UNITED STATES PATENT AND TRADEMARK OFFICE

APPLICATION NO.	FILING DATE	FIRST NAMED INVENTOR	ATTORNEY DOCKET NO.	CONFIRMATION NO.
10/519,877	02/17/2006	Ichiro Hase	09792909-6063	7426
26263 7590 10/17/2007 SONNENSCHN NATH & ROSENTHAL LLP P.O. BOX 061080 WACKER DRIVE STATION, SEARS TOWER CHICAGO, IL 60606-1080			EXAMINER PATTON, PAUL E	
			ART UNIT 2822	PAPER NUMBER
			MAIL DATE 10/17/2007	DELIVERY MODE PAPER

Office Action Summary	Application No. 10/519,877	Applicant(s) HASE, ICHIRO	
	Examiner Paul E. Patton	Art Unit 2822

DETAILED ACTION

FIG.12

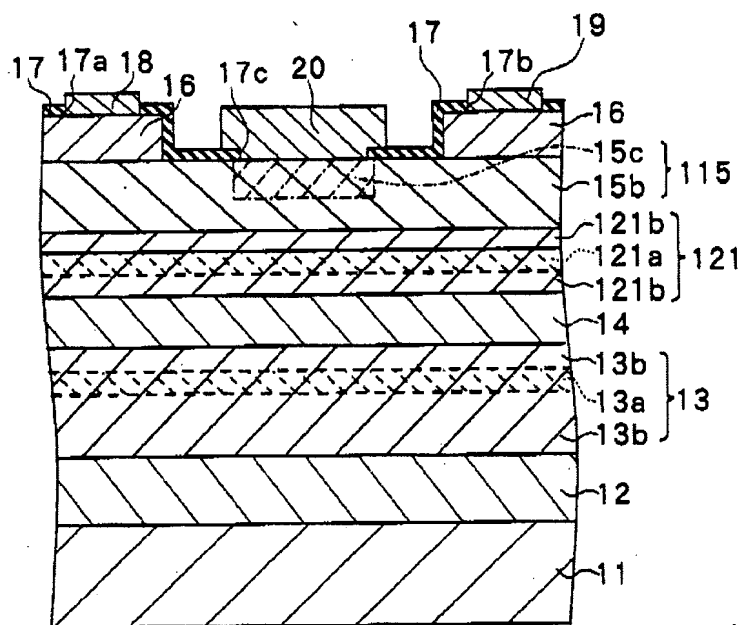
3. As to claim 1, Hase discloses and shows (Fig 12) a semiconductor device having a source electrode 17a), a drain electrode (17b), a gate electrode (20) disposed between the source electrode and the drain electrode, and a channel layer (14) composed of a semiconductor which serves as a current path between the source electrode and the drain electrode, characterized by comprising: a first barrier layer (115) composed of a semiconductor having a p-type conductive region doped with a p-type impurity of high concentration under the gate, a second barrier layer (13) disposed on an opposite side of said first barrier layer while placing said channel layer in between and is composed of a semiconductor having an electron affinity smaller than that of said channel layer, and a third barrier layer (121) disposed between said first barrier layer and said channel layer and is composed of a semiconductor having an electron affinity smaller than that of said channel layer, wherein a relation below:

$$\chi_1 - \chi_3 \leq 0.5 * (E_{g3} - E_{g1}) \quad (1)$$

is satisfied, where x_1 is electron affinity of said first barrier layer, E_{g1} is a band gap thereof, x_3 is electron affinity of said third barrier layer, and E_{g3} is a band gap thereof.

Note that due to the materials comprising layer 15b (GaAs) and 121a (AlGaAs) equation 1 is inherently satisfied. (Column 4, lines 22-68 & column 8, line 51—column 9, line 5).
